STAFF REPORT
CITY OF BEVERLY HILLS

**For the Design Review Commission
Meeting of March 3, 2011**

SUBJECT: A request for an R-1 Design Permit to allow a façade remodel of an existing two-story single-family residence, located in the Central Area of the City north of Santa Monica Boulevard at **724 North Elm Drive** (PL 103 8778).

Continued from the February 3, 2011 Design Review Commission meeting.

Elevation – 2/3/2011

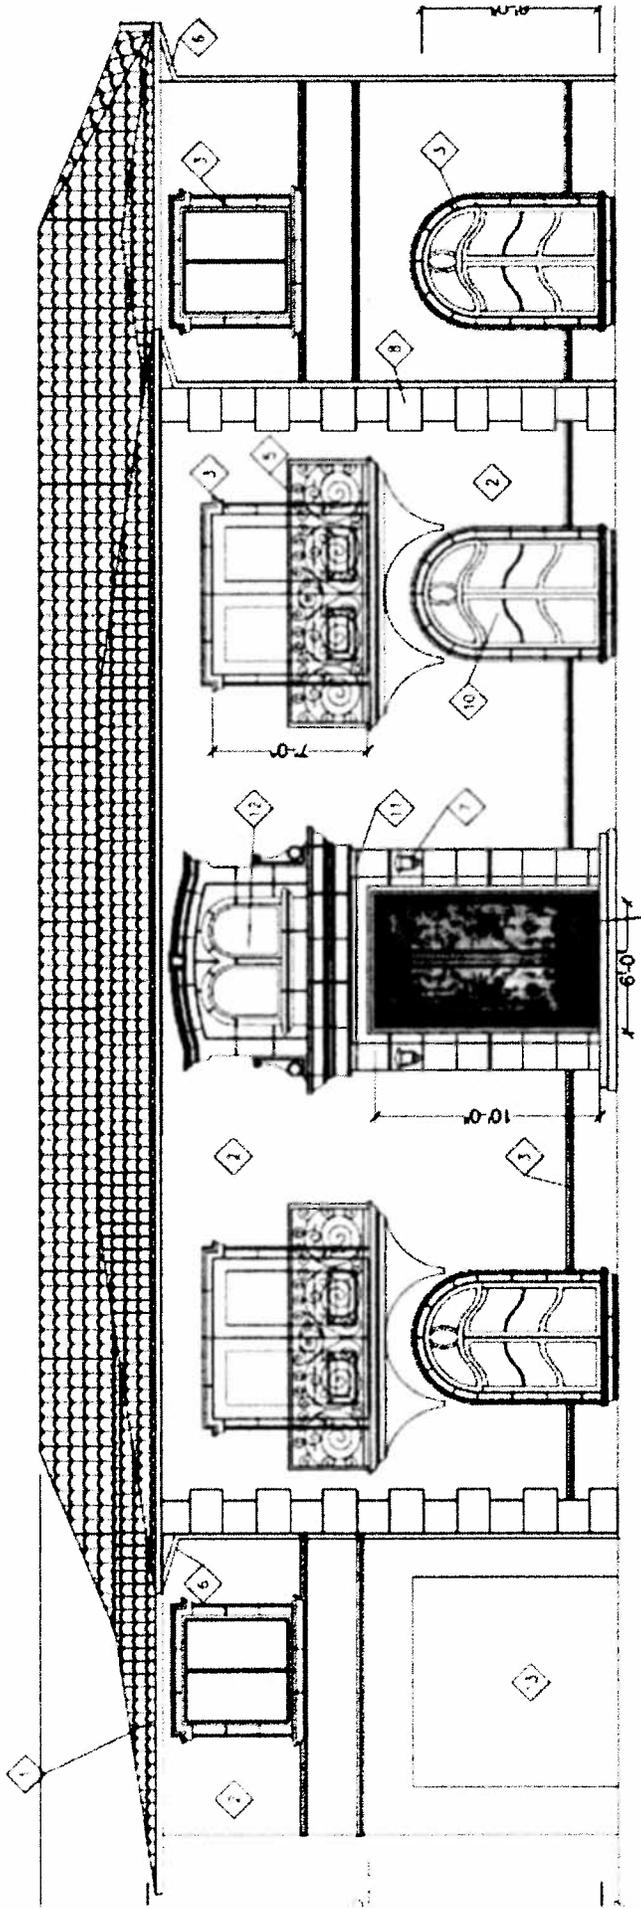
Design Review Commission Requests February 3, 2011 Meeting	Applicant's Response
1. All windows and doors should contain straights (not eyebrow) horizontal mullions.	1. All the window and door mullions are not straight.

3. Provide a sample of the paving material(s).	3. The applicant will be provided a sample of the material at the March 3, 2011 meeting.
4. The entry should be redesigned to be a one-story portico with separate windows above. Provide a section of the entry.	4. The applicant has redesigned the entry per the Commission's direction. A section of the entry has been provided on sheet A-6.

5. The railing design should be simplified.	5. The applicant is now proposing to maintain the existing railings on the residence.
6. Provide detail drawings of the window edging.	6. The applicant has provided detailed drawings of the window edging on sheet A-6.

7. Provide a section detail of the windows.	7. The applicant has provided a section detail of the windows on sheet A-6.
8. Provide fully dimensioned details of the proposed exterior lighting fixtures.	8. The applicant has provided further details of the exterior lighting in Exhibit A.

9. The proposed entry door is not internally compatible with other elements of the design. A new door design which is more consistent with the Italianate style of architecture should be provided.	9. The applicant is proposing a new door design for the Commission's consideration.

10. Shutters or side light options should be added to the second story windows and French doors.	10. The applicant has added side lights along both sides of the second story French doors.
